## ADDENDUM #6

DCA Project No.: 22-136  
Project Name: York Region Warehouse Upgrades

**Addendum #:** E01

2 ELECTRICAL ROOM LAYOUT - NEW LAYOUT  
SCALE: 1:100

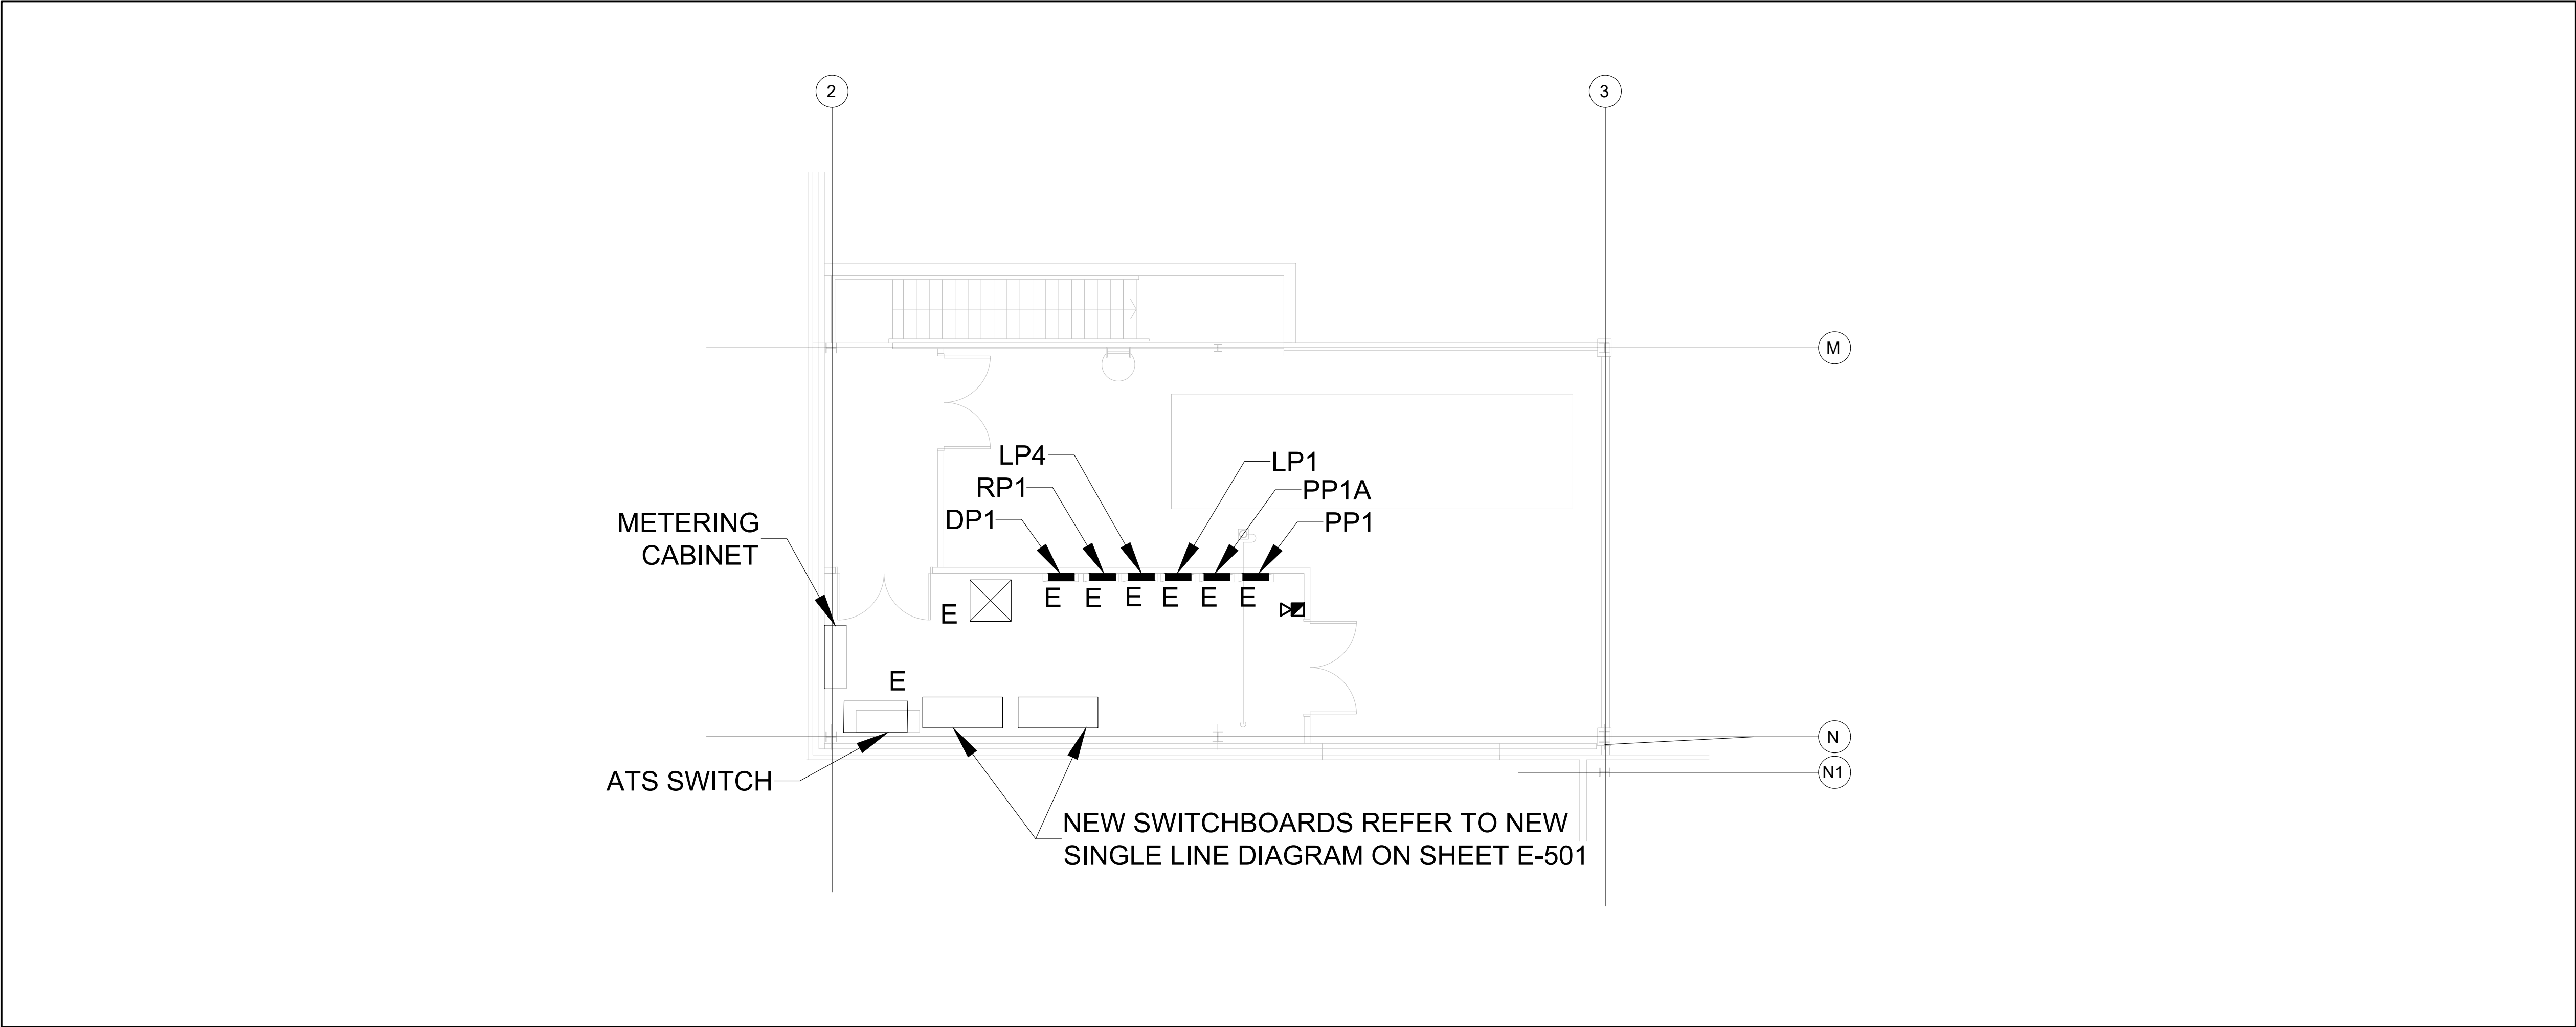
- .5 Drawing – E-106 – POWER & SYSTEMS PLAN – ELECTRICAL ROOM**
  - i) Refer to attached drawing general sheet notes for new switchboard space constraints.

- SPACE CONSTRAINTS FOR NEW SWITCHBOARD LEADING TO THE ELECTRICAL ROOM ARE AS FOLLOWS. THE STAIRS LEADING UP TO THE ELECTRICAL ROOM IS 3 FEET 10 INCHES WIDE. THE DOUBLE DOOR AT THE END OF THE STAIRS TO THE ELECTRICAL ROOM IS 5 FEET 8 INCHES WIDE. ARCHITECT WILL PROVIDE A 5 FEET BY 5 FEET OPENING IN THE ELECTRICAL ROOM SOUTH WALL. REFER TO ARCHITECTURAL DRAWINGS FOR DETAILS. CONSULT WITH SWITCHBOARD MANUFACTURER FOR PACKAGING AND DELIVERY TO ENSURE FEASIBILITY ON DELIVERY DUE TO SPACE CONSTRAINTS.

DRAWING No.  
E-201

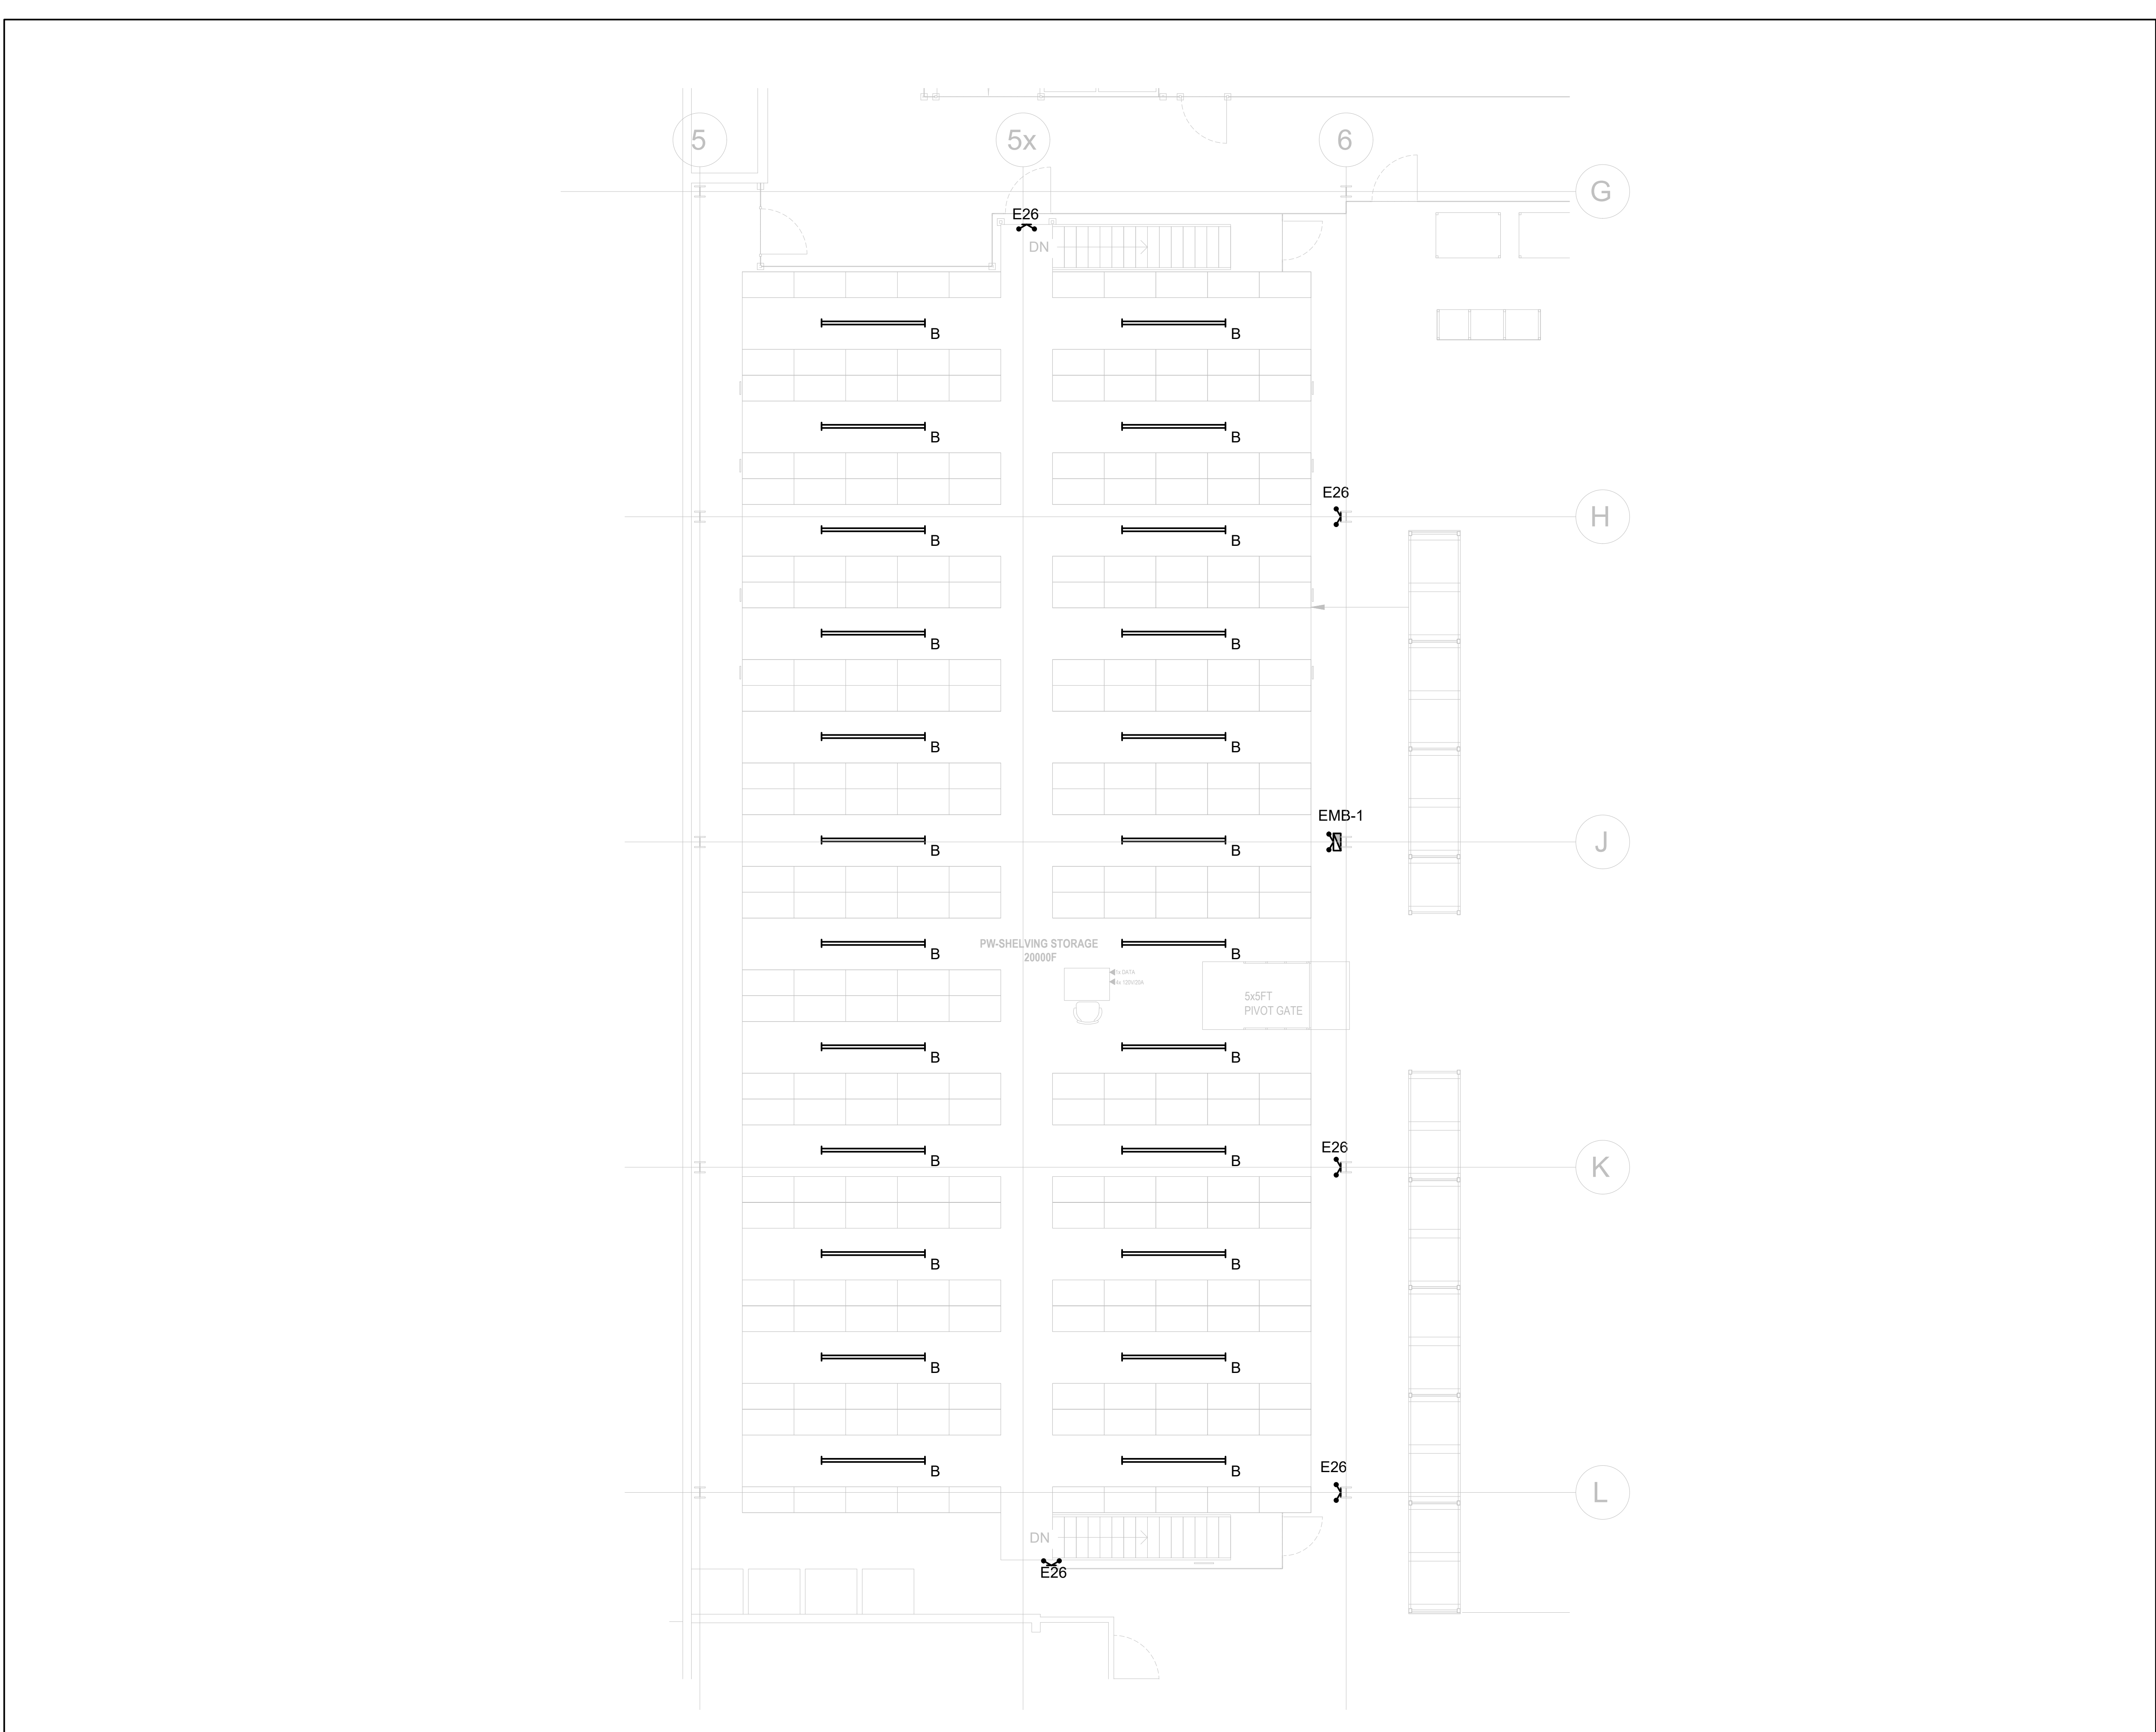
- i) Updated FB1 lighting fixtures to fixture A.
  - ii) Refer to attached drawing general sheet notes.
- .8 Drawing- E-202- LIGHTING LAYOUT PUBLIC WORKS LEVEL 2 – MAIN FLOOR**

**E-202**

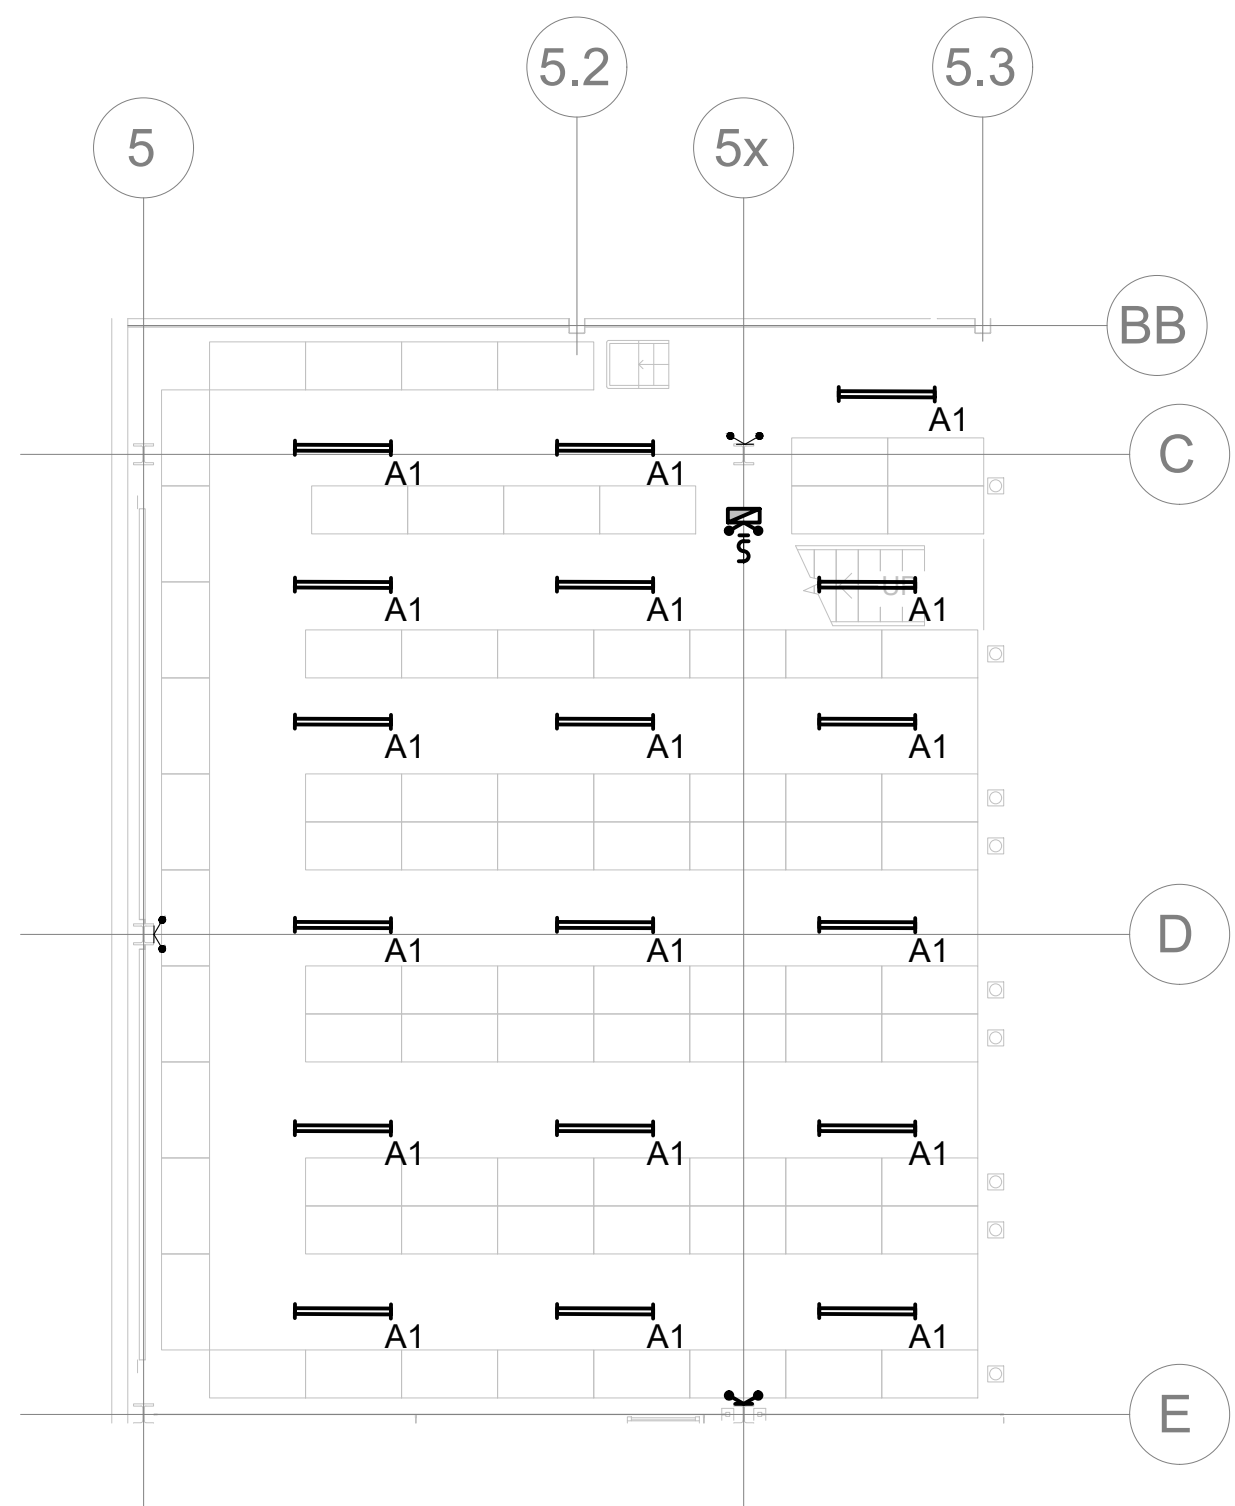
- i) Refer to attached drawing general sheet notes.
- .9 Drawing- E-204- LIGHTING LAYOUT - MEZZANINE LEVEL**
  - i) Refer to attached drawing general sheet notes.
